Access Compliance Report

Public Rights-of-Way

Intersection ID: 48787	Main Street: LOST_PINE_RD	Cross Street: LOST_OAK_RD	Location: S
ADA ID: 2F01BDA2A530	Ramp Type: PerpDiag	Initial Pass/Fail: Fail	Overall Compliance: No
			Severity Score: 33.75

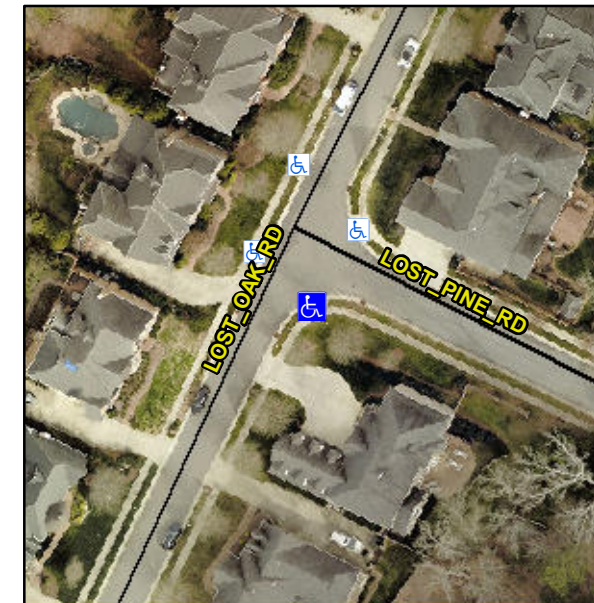
R304.5.1, R304.5.3

Compliance	Description	Data	Compliance	Description	Data
N/A	Ramp Length (in)	95.0	Yes	Ramp Slope (%)	6.3
No	Ramp Width (in)	40.0	No	Ramp XSlope (%)	8.4
N/A	Flare Type LT	N/A	N/A	Flare Type RT	N/A
N/A	Flare Slope LT (%)	N/A	N/A	Flare Slope RT (%)	N/A
N/A	Flare Traversable LT?	N/A	N/A	Flare Traversable RT?	N/A
N/A	Landing Length (in)	N/A	N/A	DWS Provided?	N/A
N/A	Landing Width (in)	N/A	N/A	DWS Contrast?	N/A
N/A	Landing Slope (%)	N/A	N/A	DWS Length (in)	N/A
N/A	Landing X Slope (%)	N/A	N/A	DWS Full Width?	N/A
N/A	Landing Curb? (Y/N)	N/A	N/A	DWS Offset (in)	N/A
N/A	Shared Landing?	N/A			
N/A	Gutter Ponding?	N/A	N/A	Gutter Slope (%)	N/A
N/A	Gutter Lip Ht (in)	N/A	N/A	Gutter X Slope (%)	N/A
N/A	Painted X Walk1?	No	N/A	Painted X Walk2?	No
	X Walk 1 Direction	To NE		X Walk 2 Direction	To NW
N/A	X Walk 1 Width (in)	N/A	N/A	X Walk 2 Width (in)	N/A
	X Walk 1 Slope (%)	2.6		X Walk 2 Slope (%)	2.5
	X Walk 1 X Slope (%)	4.1		X Walk 2 X Slope (%)	3.4

Remove & Replace Curb Ramp With Two New Directional Ramps or Equivalent.
